## United States Patent and Trademark Office

APPLICATION NO.	FILING DATE	FIRST NAMED INVENTOR	ATTORNEY DOCKET NO.	CONFIRMATION NO.	
10/628,588 07/28/2003		Jeffrey K. Drogue	6970.02	4659	
75	7590 05/19/2006		EXAMINER		
David E. Bruhn DORSEY & WHITNEY LLP			BOGART, MICHAEL G		
	perty Department	ART UNIT	PAPER NUMBER		
	Street, Suite 1500	3761			
Minneapolis, MN 55402-1498			DATE MAILED: 05/19/2006

## **DETAILED ACTION**

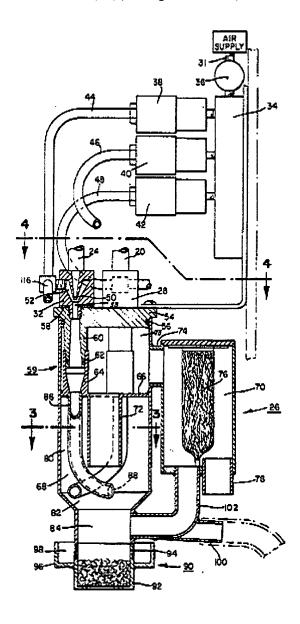
Ciavattoni teaches vacuum connector (10) located in the same room as the point of use of

a separation chamber (26) in communication with the inlet (64);

a baffle (66) operably mounted in said chamber (26) to cooperate with the inlet (64) for optimizing the separation of liquid and gaseous material;

an air pathway (70) in communication with the separation chamber (26) and the outlet (84); and

a fluid pathway (100) separate from the air pathway (70), and in communication with the separation chamber (26) and the outlet (84)(see figure 2, infra).

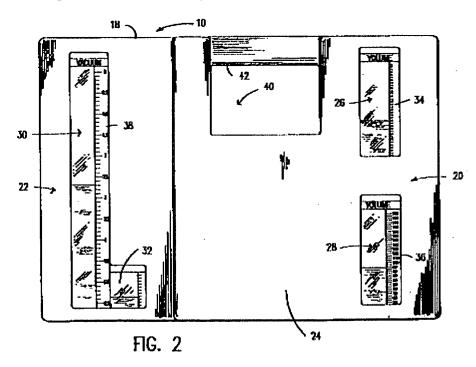
Goosen teaches a flow volumetric flow indicator (26)(figure 2, infra).

At the time of the invention, it would have been obvious to one of ordinary skill in the art to add the flow indicator of Goosen to the evacuation apparatus of Ciavattoni in order to provide a means of monitoring the flow rate of the system.

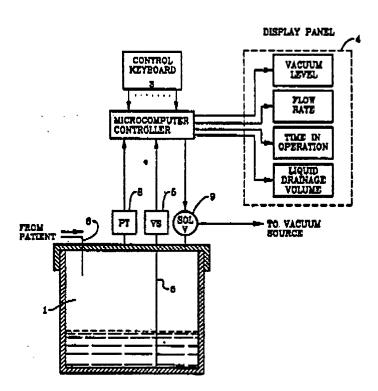
Walker teaches a keyboard (3) for controlling a medical suction apparatus (see figure 1, infra).

At the time of the invention, it would have been obvious for one of ordinary skill in the art to add the keyboard of Walker to the evacuation apparatus of Ciavattoni in view of Goosen in order to provide a means of controlling the air pressure and vacuum applied to a patient.
